Exterior Renovations

Cascadian Apartments 15517 NE 12th St., Bellevue WA 98007

ADDENDUM NO. 2

CONTRACT NUMBER: DW2400631

3 SECTION - EXTERIOR DOOR HEAD, TYP.
SCALE: 6" = 1'-0"

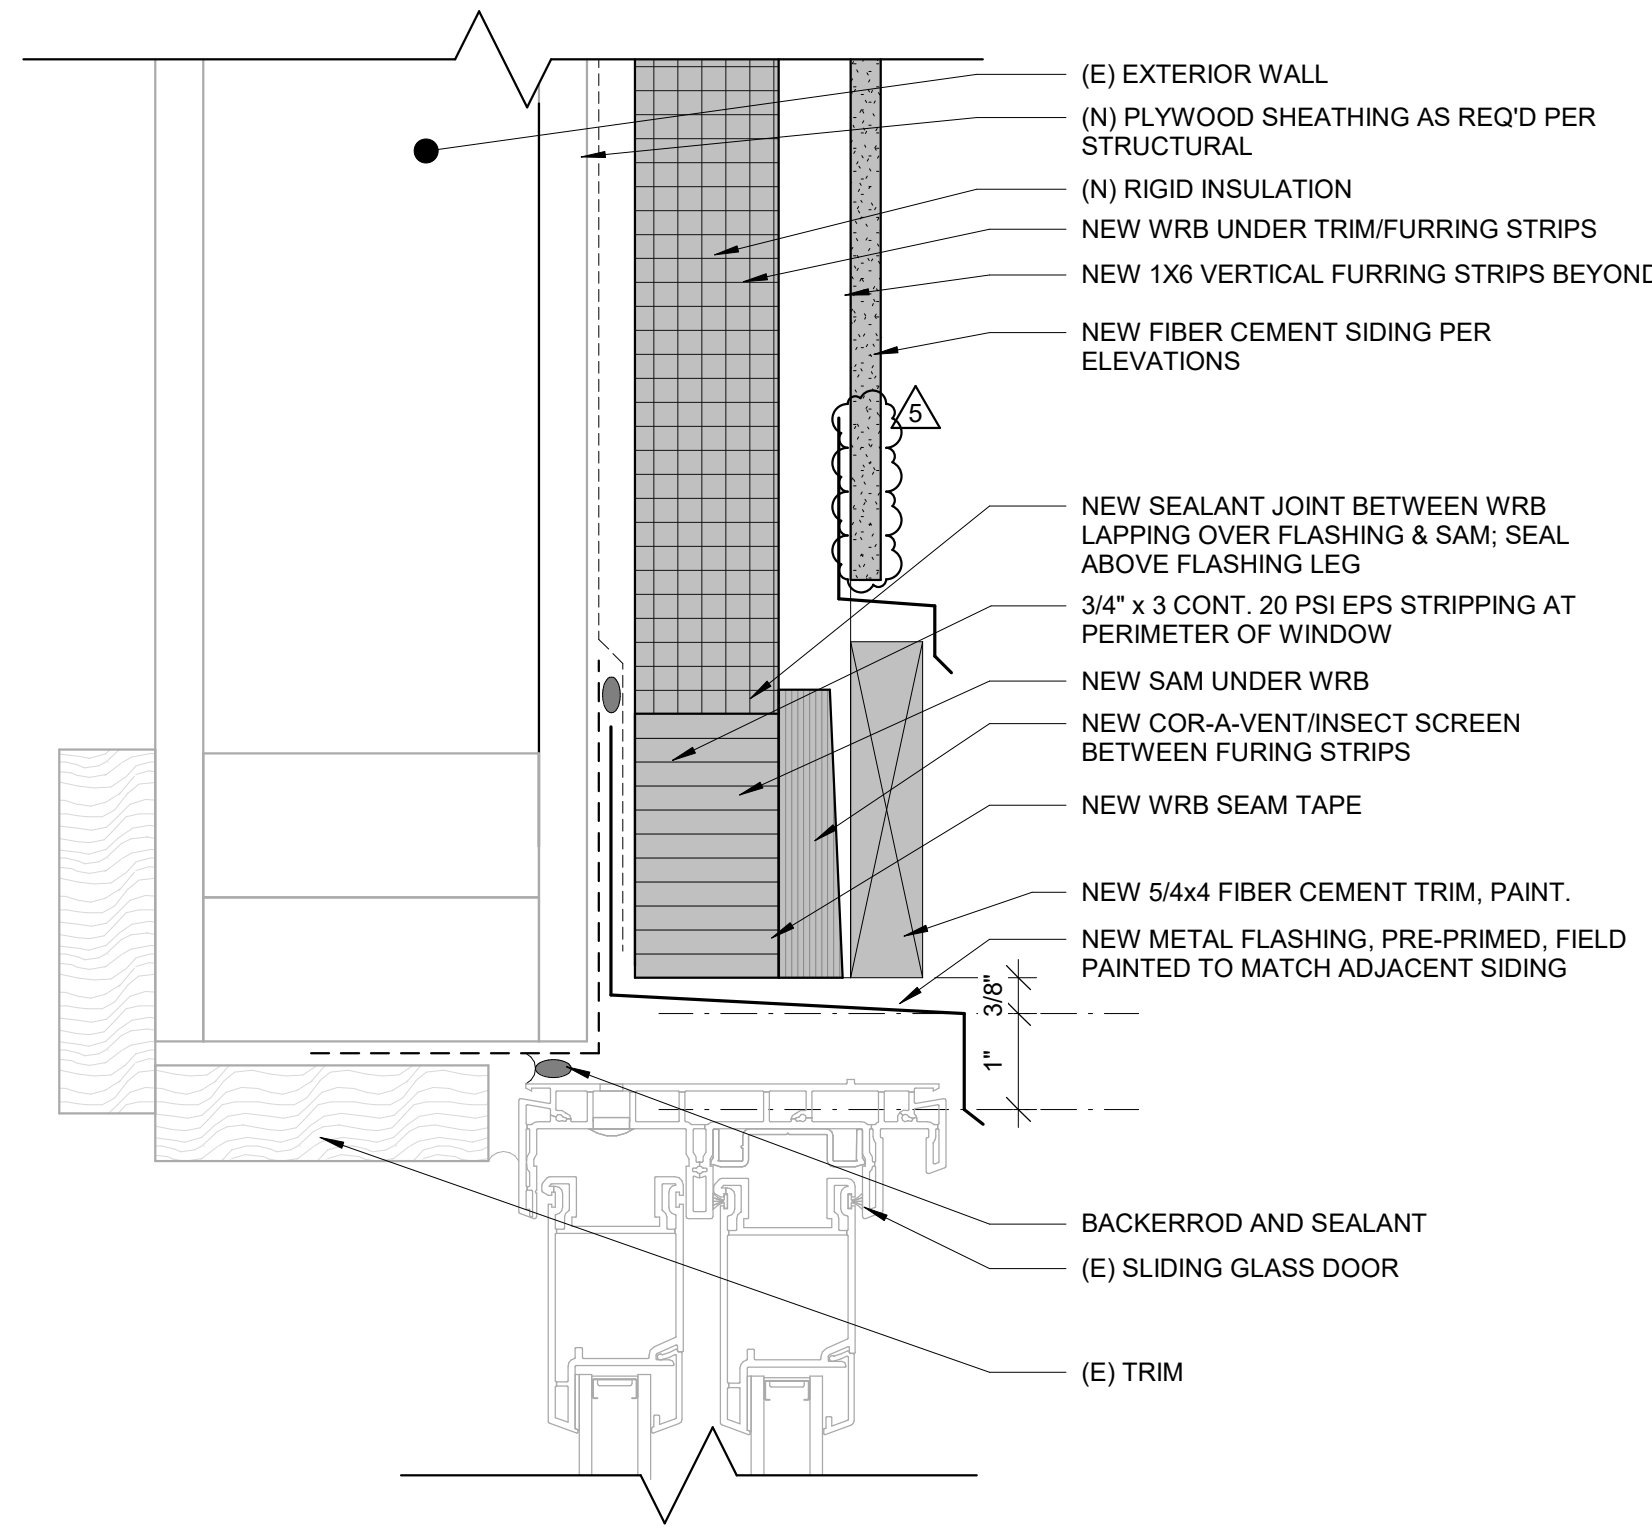
Q9: 3,6-A570 - Details call for J-trim at window, door head.

A: Detail 3,6/A570 revised to show no J-Trim.

2 PLAN - EXTERIOR DOOR JAMB, TYP.
SCALE: 6" = 1'-0"

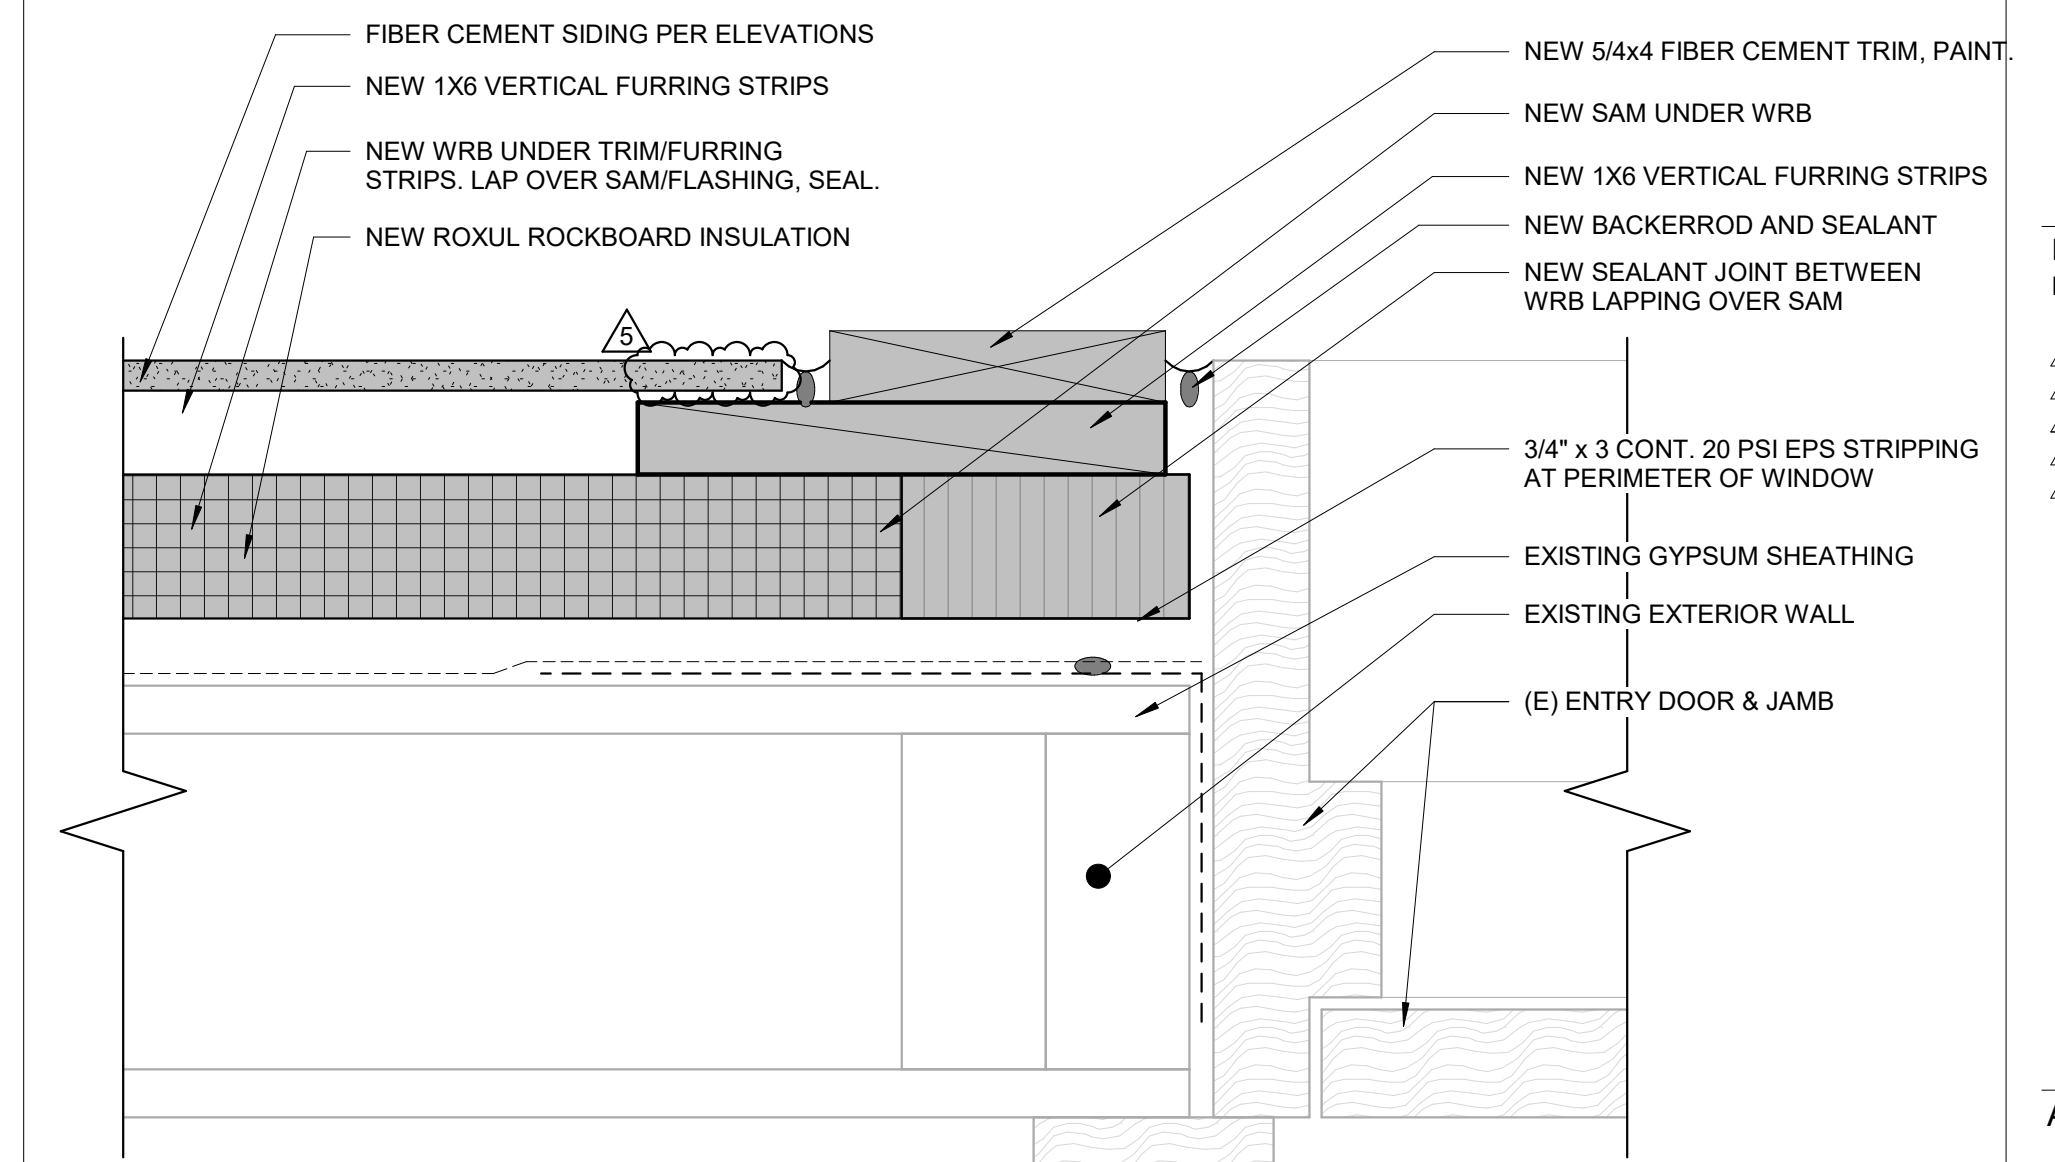
Q8: A570 - Detail calls for J-trim, N/A due to lap siding at these locations.

A: Detail 2/A570 revised to show no J-Trim.

7 SECTION - EXTERIOR SLIDING GLASS DOOR SILL @ LEVEL 2-3, TYP.
SCALE: 3" = 1'-0"

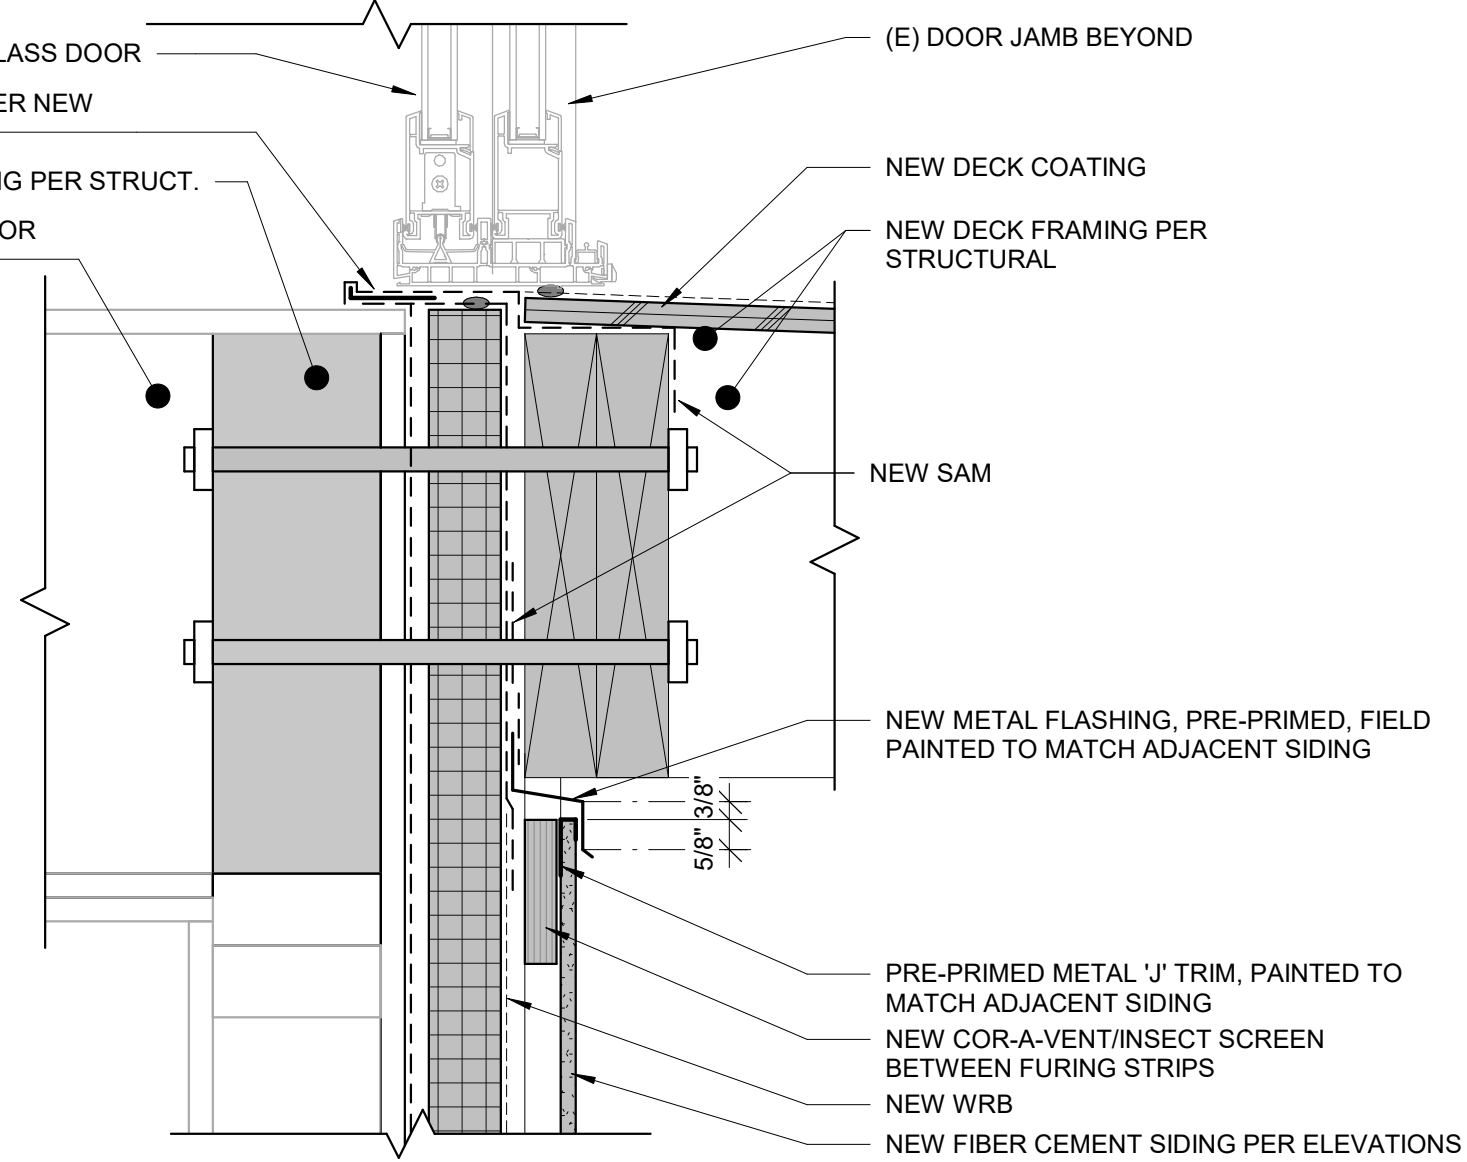
Q10: 7-A570 – Clarify: No interior work required due to blocking below SGD for fasteners corresponding with deck ledgers.

A: Patch, repair if damaged.

610 WINDOW TYPES - VINYL
SCALE: 3/8" = 1'-0"

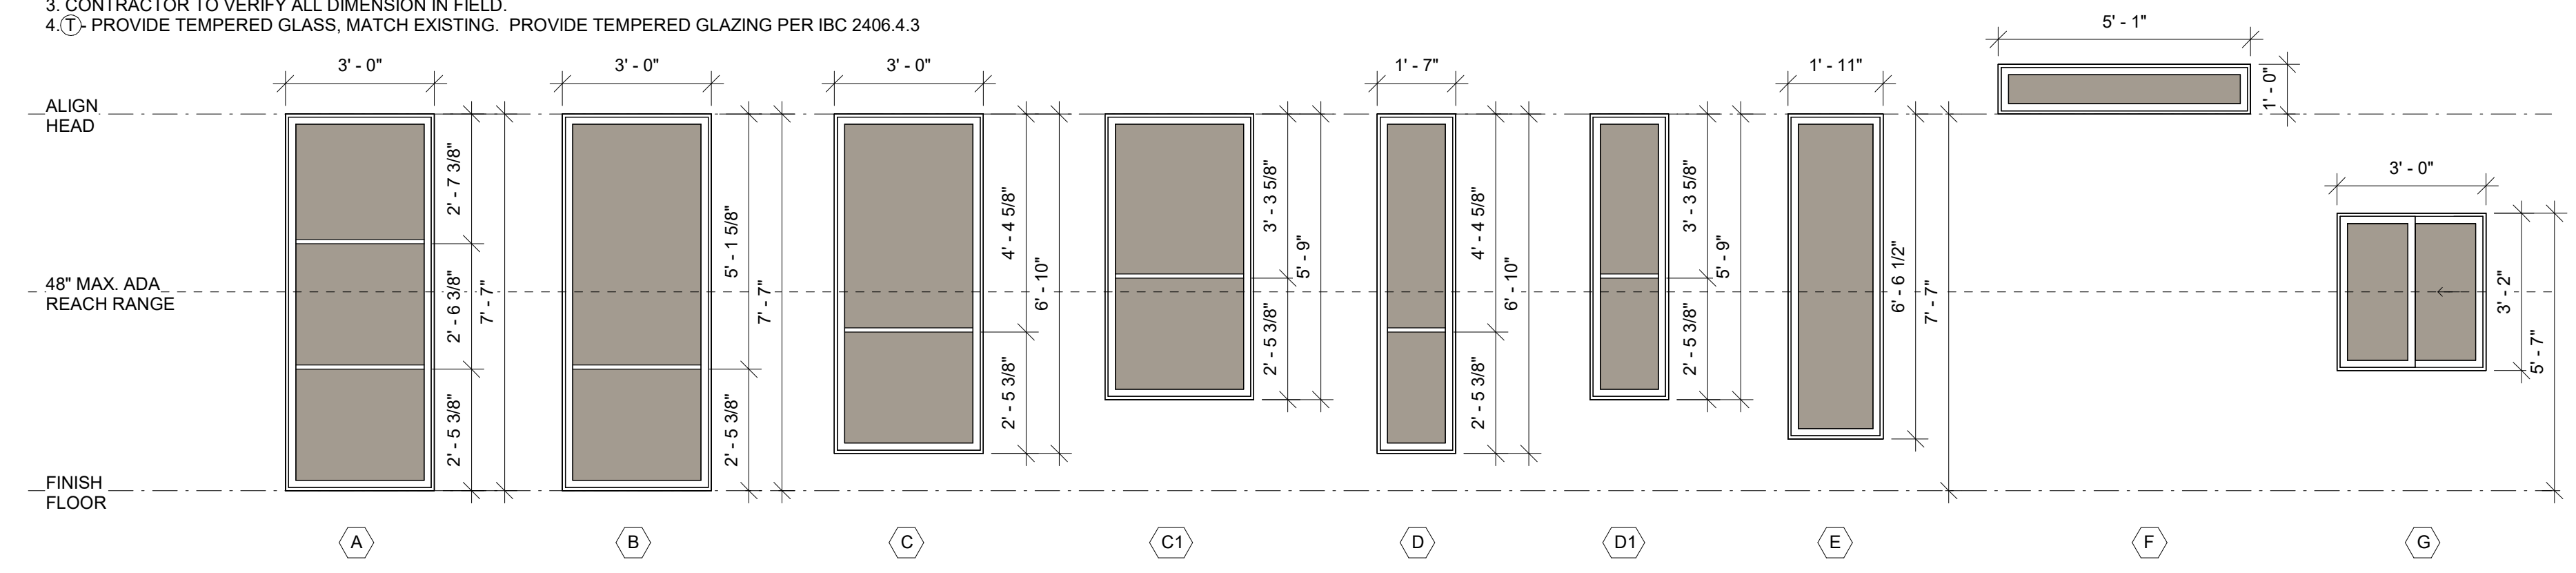
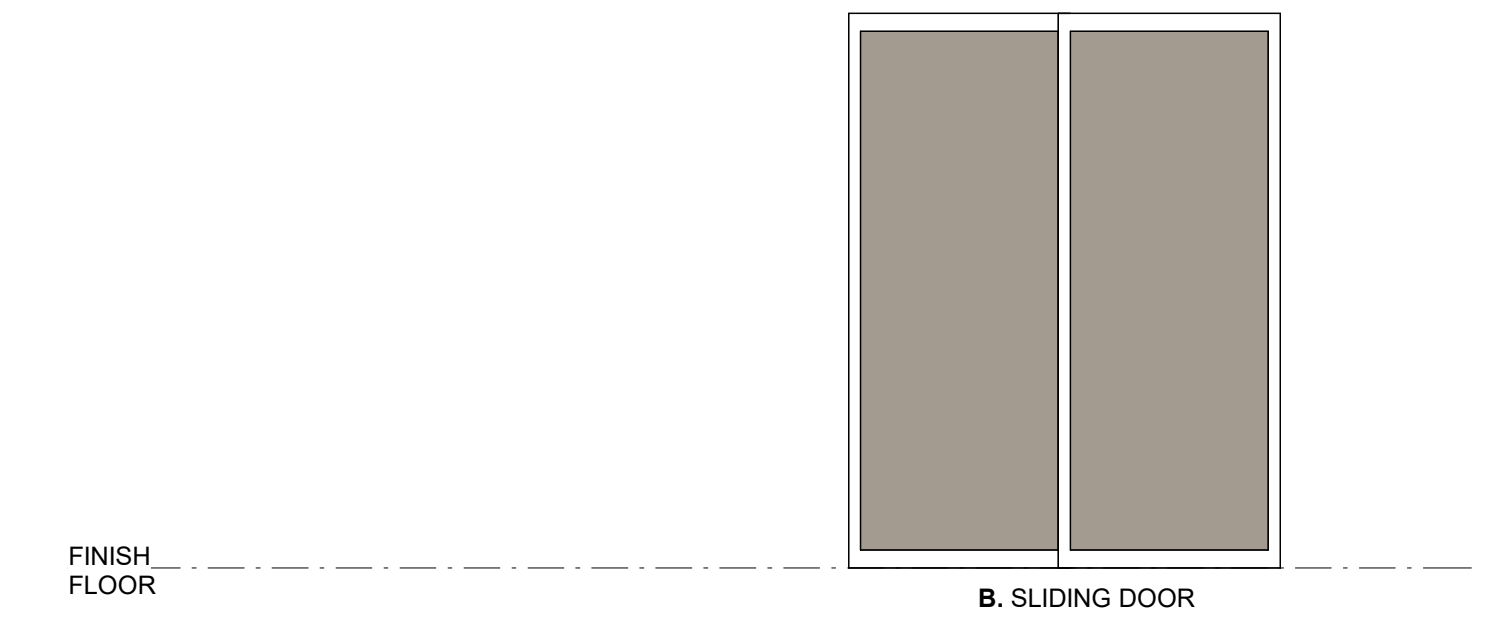
Q19: Windows – There were a couple questions about the window specifications and SHGC performance standards.

A: Contractor responsible to confirm all window and door opening sizes and allow for the specified installation methods including all flashing and weatherization measures and including any alterations to the openings. If any existing window configurations cannot be matched with the new windows, such as check rails or muller units, match as closely as possible. The window specifications have been changed. See attached revised A600.

U-factor = 0.30 Max

SHGC = 0.38 Max

Ply-Gem Builder Series 200 Windows

Ply-Gem Builder Series 460 Sliding Glass Doors

Provide Nail Flanges

Provide Insect Screens

White Frame
